Ref:	NR/L2/ELP/27009/MOD C70
Issue:	1
Date:	03/12/2011
Compliance date:	03/03/2012
Page	1 of 2

OVERHEAD LINE CAMPAIGN CHANGES – DATA SHEET

70

RENEW DEP STALKS WITHOUT END NUTS.

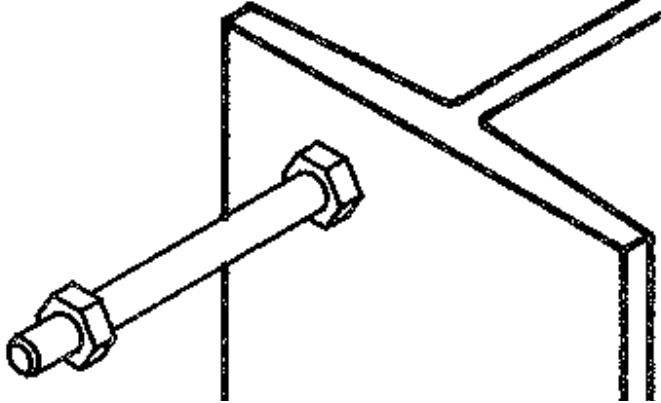
OVERHEAD LINE CAMPAIGN CHANGES – DATA SHEET	
70	RENEW DEP STALKS WITHOUT END NUTS.
COMPONENT	Designated Earthing Point (DEP) stalks without retaining nuts fitted.
PROBLEM	Early designs of DEP stalk did not have a retaining nut fitted leading to an increased risk of the earth sliding off the DEP stalk.
ACTION REQUIRED	<p>Replace DEP stalks with stalks that have threads cut at both ends and add retaining nut.</p> <p>See OLEMI drawing 1/199/814.</p>
